Groundwater Transfer Review Summary Form

Transfer/PA # T- 14815

Ground Water Review Form:

Application: T-14815

T14815 Certificate 80850

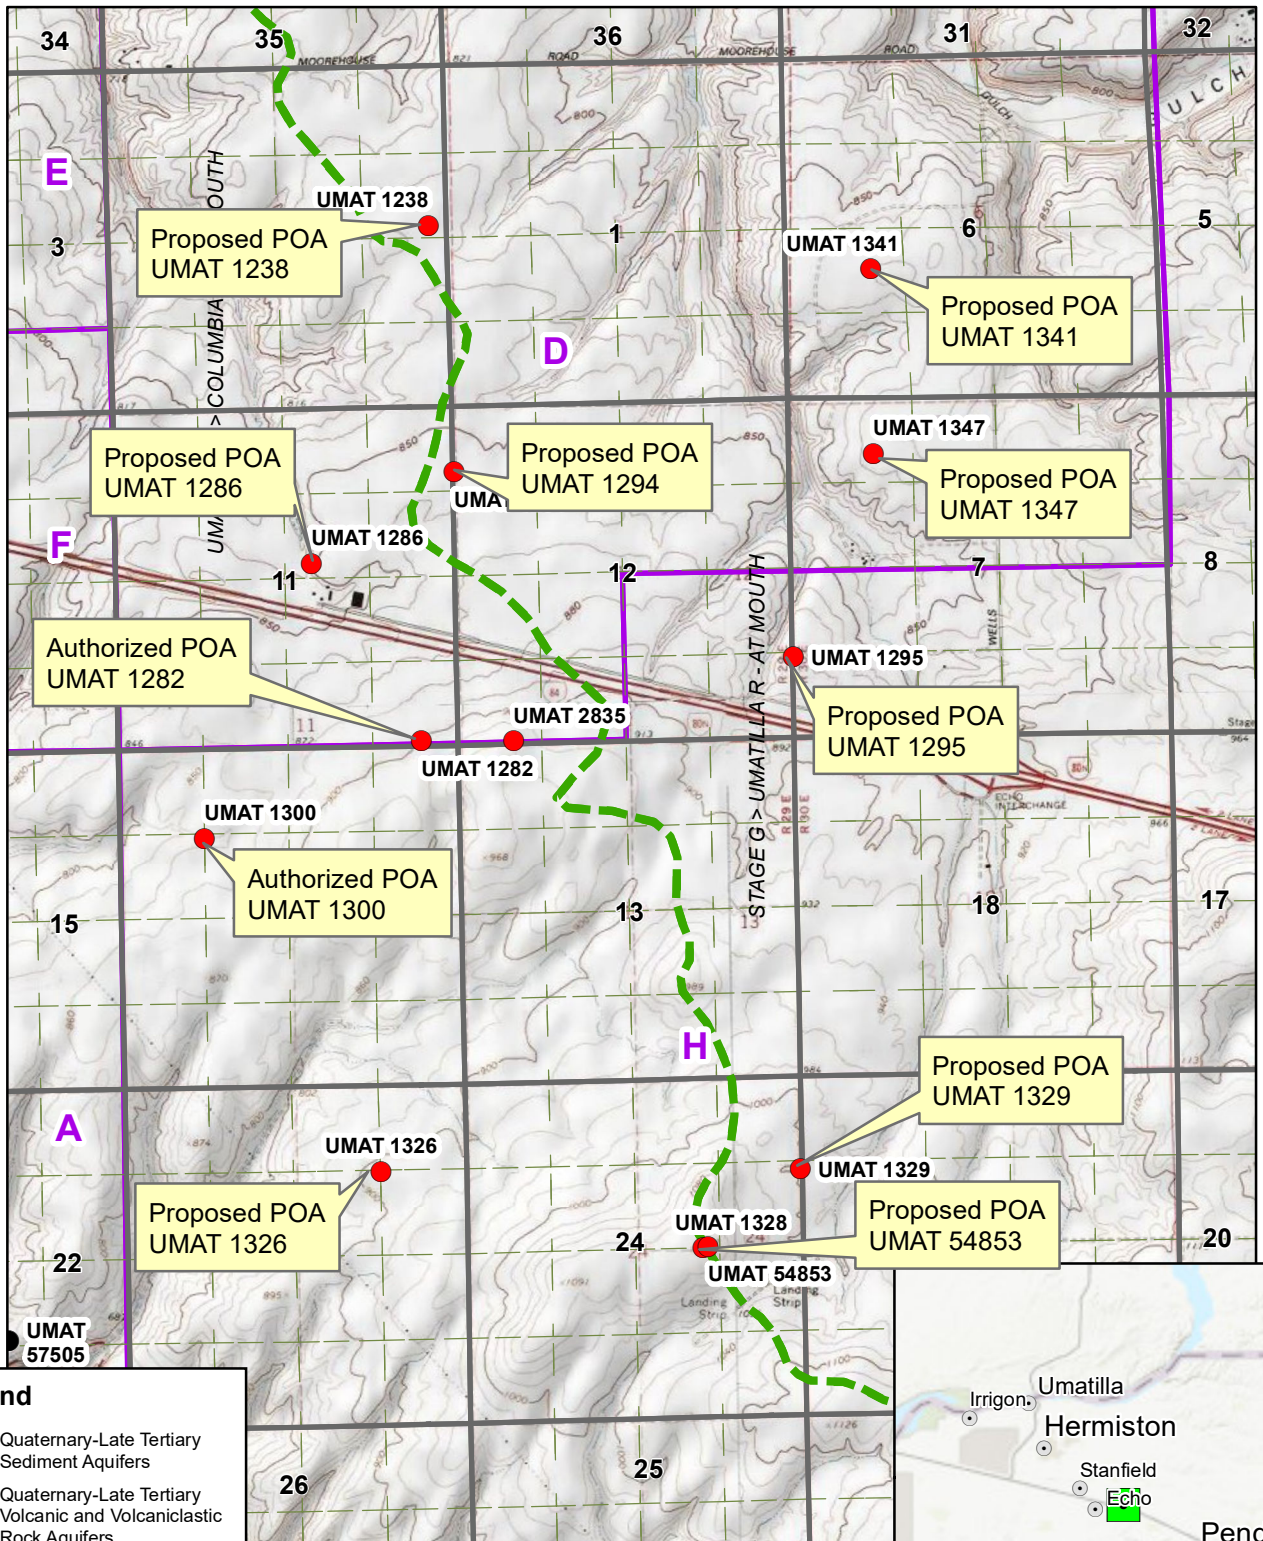
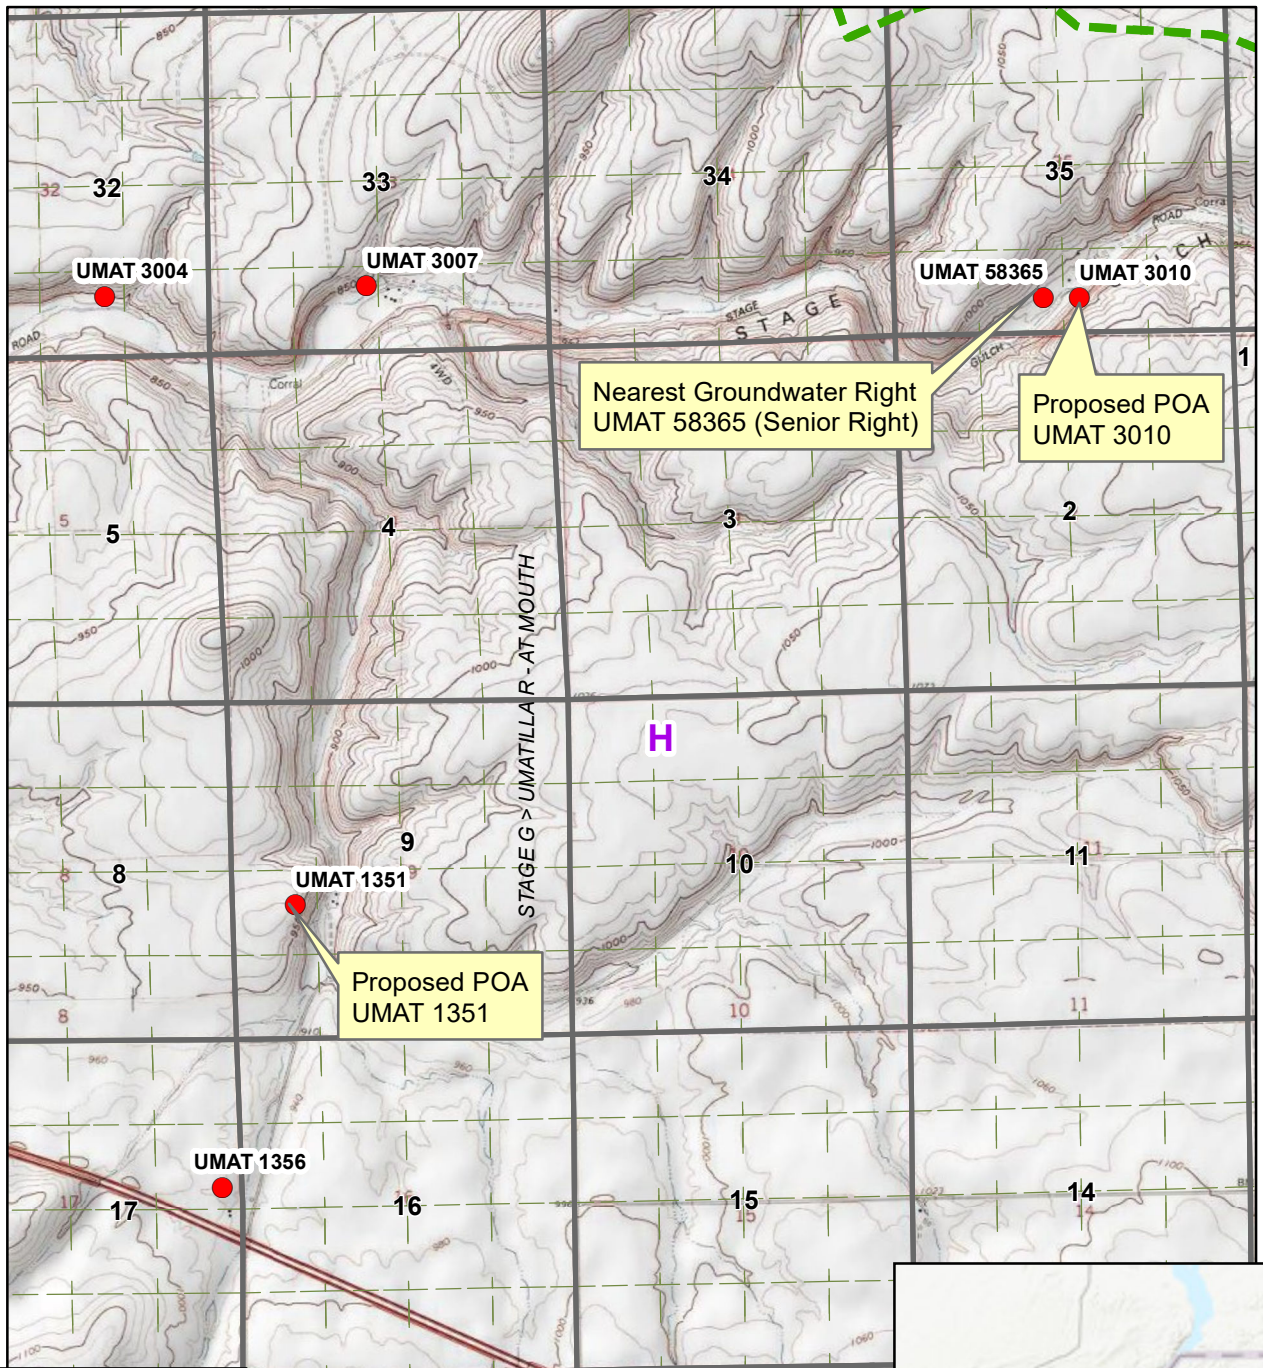
8. What conditions or other changes in the application are necessary to address any potential issues identified above: **Cert 80850 and Cert 85124 contain POAs in both Subarea D and Subarea H. The proposed APOAs are also respectively in either Subarea D or Subarea H. These two certificates have existing rate restrictions for the authorized POAs.**

Cert 80850 indicates a maximum rate of 2.9 cubic feet per second (CFS) for UMAT 1282 in Subarea D and a maximum rate of 3.04 CFS for UMAT 1300 in Subarea H for a total of 5.94 CFS between the two if the well rates are rotated. To be considered the same source, the proposed APOAs from Subarea D should be limited to the total maximum 2.9 CFS rate of UMAT 1282, and the respective APOAS from Subarea H should be limited to the total 3.04 CFS rate of UMAT 1300 in Subarea H.

T14815 Certificate 85124

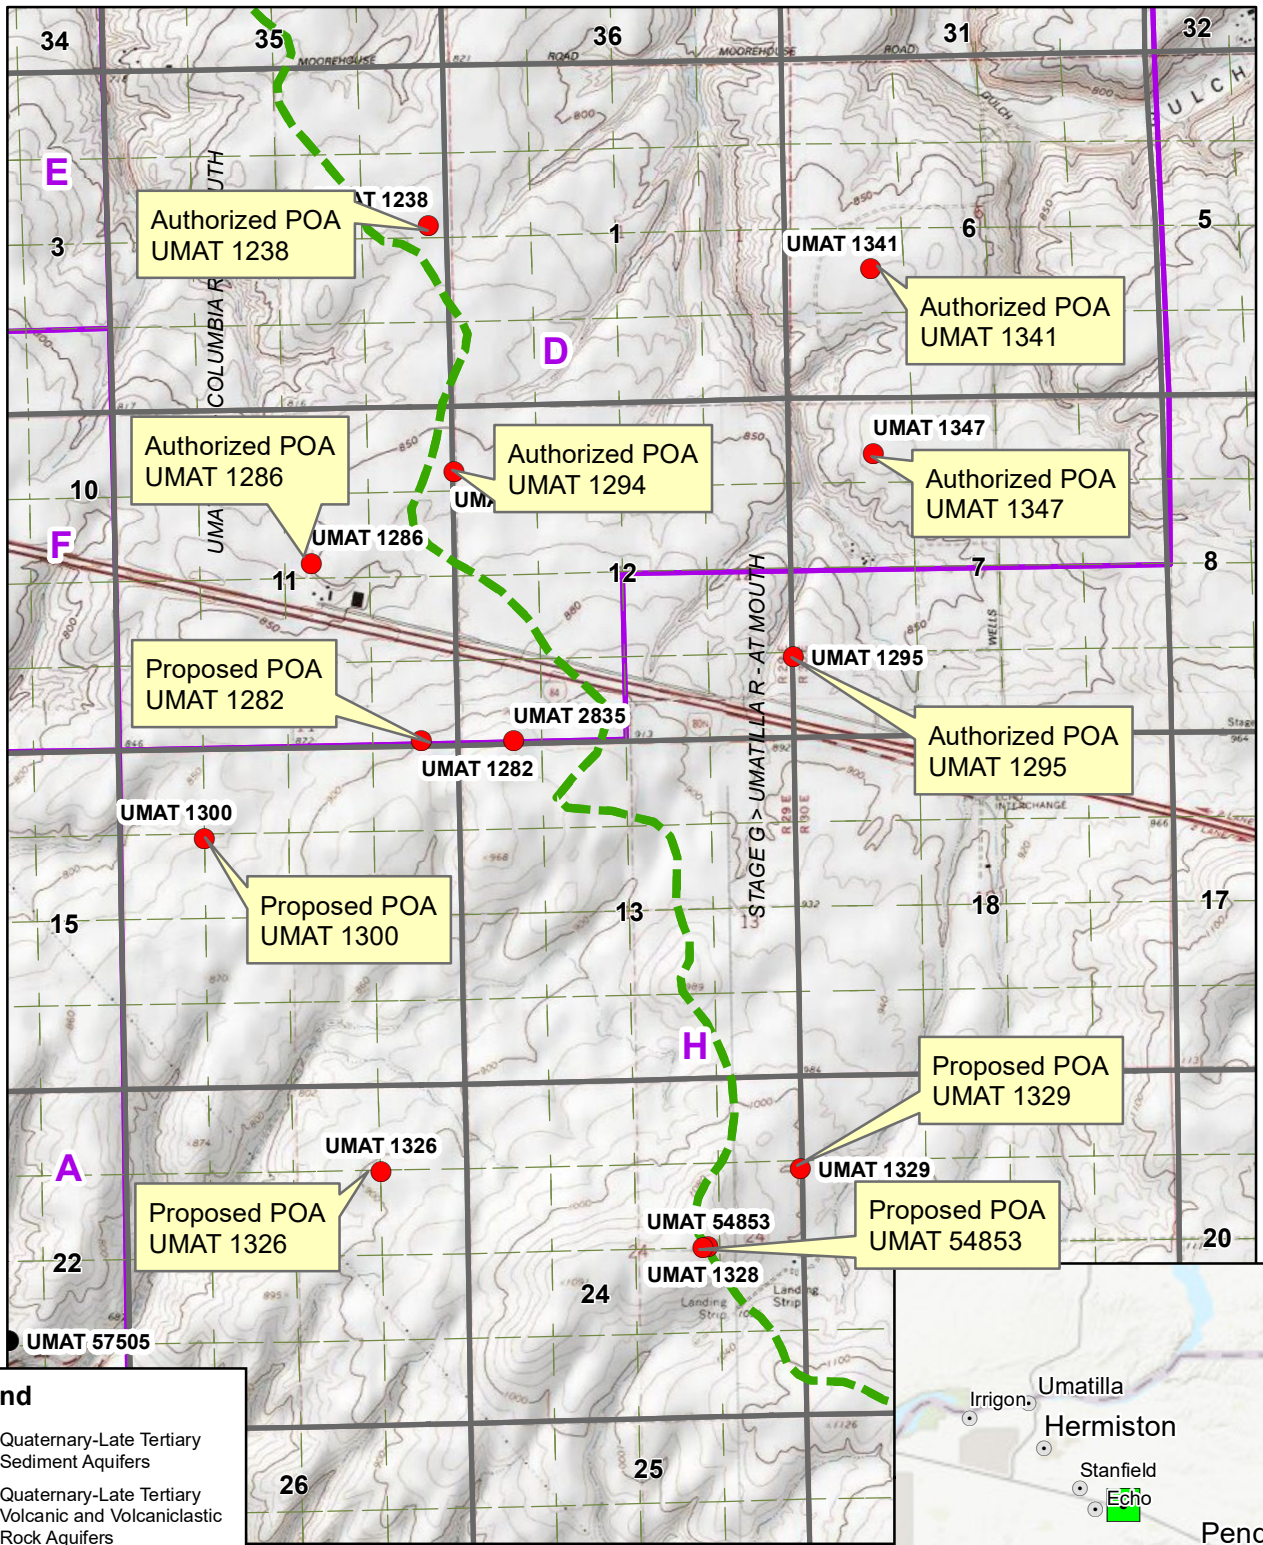
Similarly for Cert 85124, a maximum rate of 4.745 CFS is allowed for primary and supplemental irrigation of the authorized POAs in Subarea D (UMAT 1347, UMAT 1341, UMAT 1238, UMAT 1286, UMAT 1294) and a maximum rate of 4.745 CFS for UMAT 1295 in Subarea H for both primary and supplemental irrigation if available. To be considered the same source, the proposed APOAs from Subarea D should be limited to the total maximum 4.745 CFS rate of the Subarea D authorized POAs, and the respective APOAS from Subarea H should be limited to the total 4.745 CFS rate of UMAT 1295 in Subarea H.

T14815 Certificate 85124 Continued

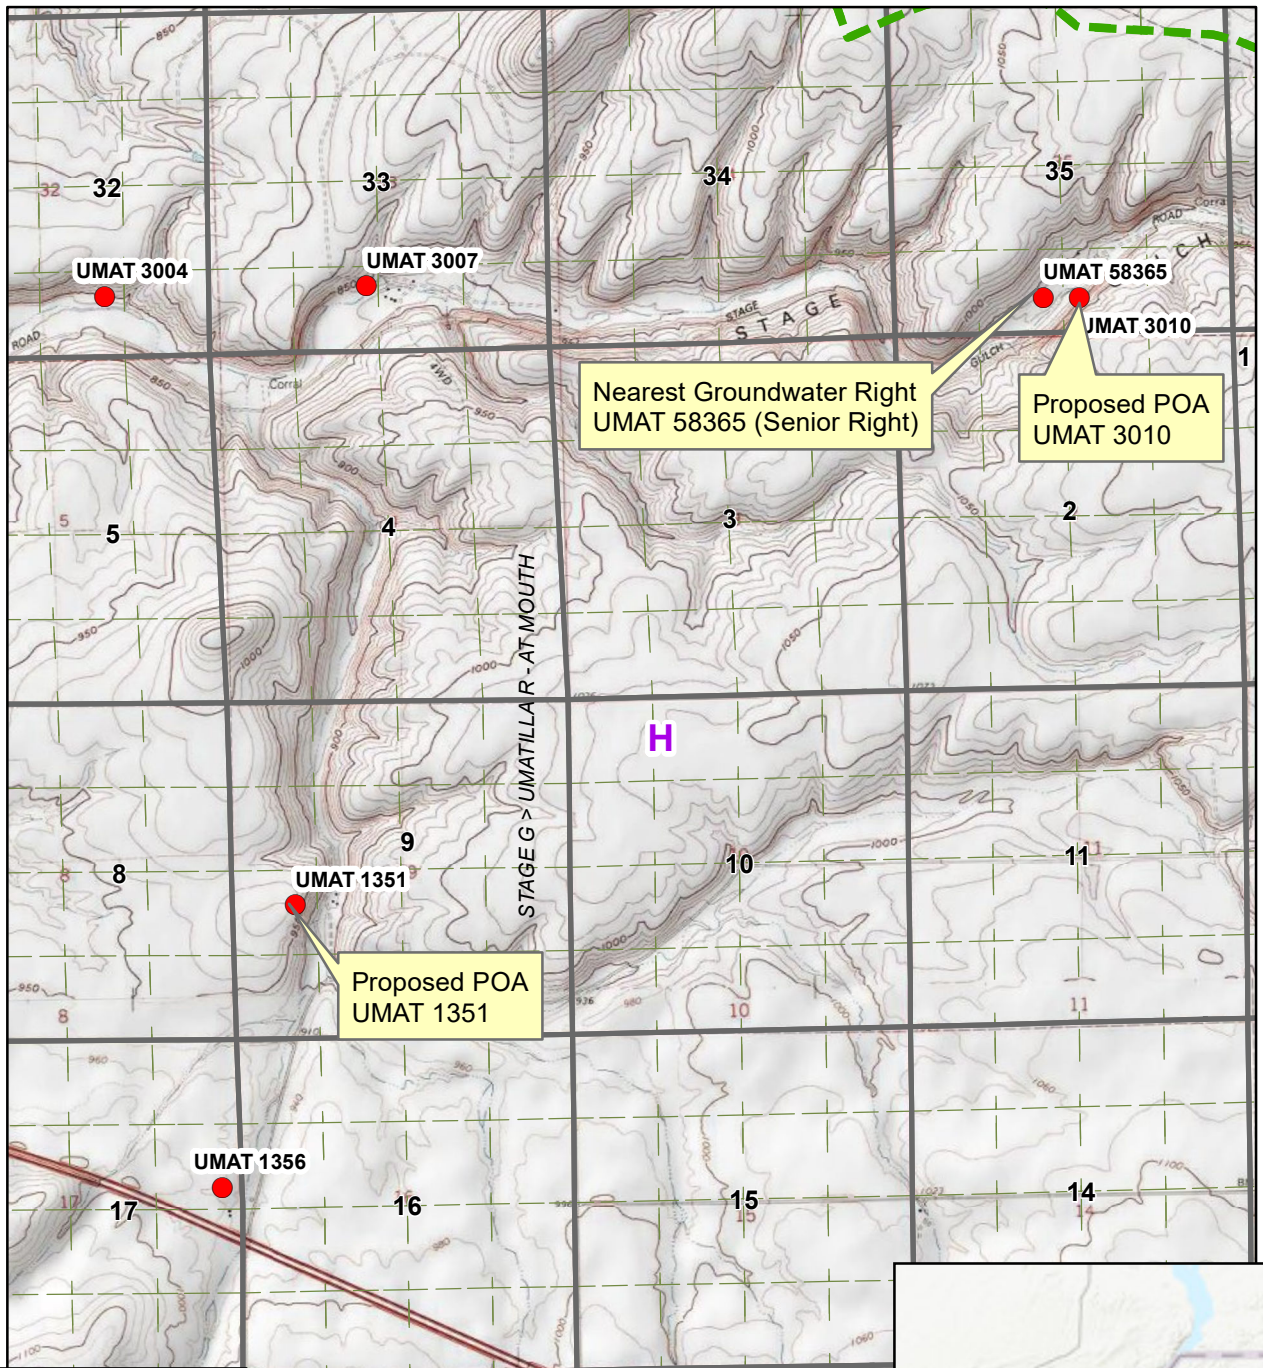
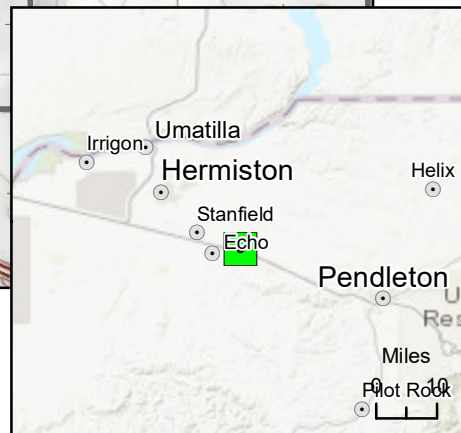
5. a) Will this proposed change, at its maximum allowed rate of use, likely result in an increase in interference with **another ground water right**?
 Yes No Comments: The proposed changes would be using the same total rate of water across more POA in an area all purchased/owned by the applicant. However, UMAT 3010 and UMAT 1351 are significantly closer to other senior water rights in Subarea H. UMAT 3010 is approximately 530 feet away from UMAT 58365, the well on the most senior right in Subarea H. UMAT 3010 and UMAT 1351 are proposed to be added to 5 certificates as part of this temporary transfer.

- b) If yes, would this proposed change, at its maximum allowed rate of use, likely result in another groundwater right not receiving the water to which it is legally entitled?
 Yes No If yes, explain: The potential interference with UMAT 58365 resulting from the proposed change was estimated using the Theis (1935) solution. Results of the analysis indicate the proposed changes are likely to result in injury of UMAT 58365. UMAT 58365 is the senior water right in Subarea H.

Based on the specific capacity estimates for surrounding wells to UMAT 3010, a yield of 3,000 gallons per minute (gpm, ~8.03 CFS) is expected. For the purposes of the analysis, 3000 gpm was used as the conservative approach. In addition, the length of the irrigation season for Stage Gulch (OAR 690-507-0770), March 1 to November 30, was used as the number of days of pumping. Pump test data in surrounding sections for basalt wells ranged between 1500 and 15000 ft²/day for transmissivity. The neighboring UMAT 58365 has over 450 feet of water column since the latest February 2026 measurement. Well yields in the surrounding sections ranged from 10 to 4800 gpm.

The modeled drawdown at 3,000 gpm is up to 375 feet of drawdown. **At max capacity of UMAT 3010, it is unlikely that the senior right will have the water it is legally entitled to at UMAT 58365.**

UMAT 3010 is proposed to be added to up to 5 certificates and there is uncertainty on the total rate that will be pumped (based on lack of historical data), therefore there is a likely chance of significant interference with UMAT 58365. If the APOA is used as proposed across all 5 certificates, it is unlikely that the senior right will have the water it is legally entitled to at UMAT 58365.

Nearest Groundwater Right
UMAT 58365 (Senior Right)

Proposed POA
UMAT 3010

It is recommended that UMAT 3010 is removed from the transfer for this application to be approved.
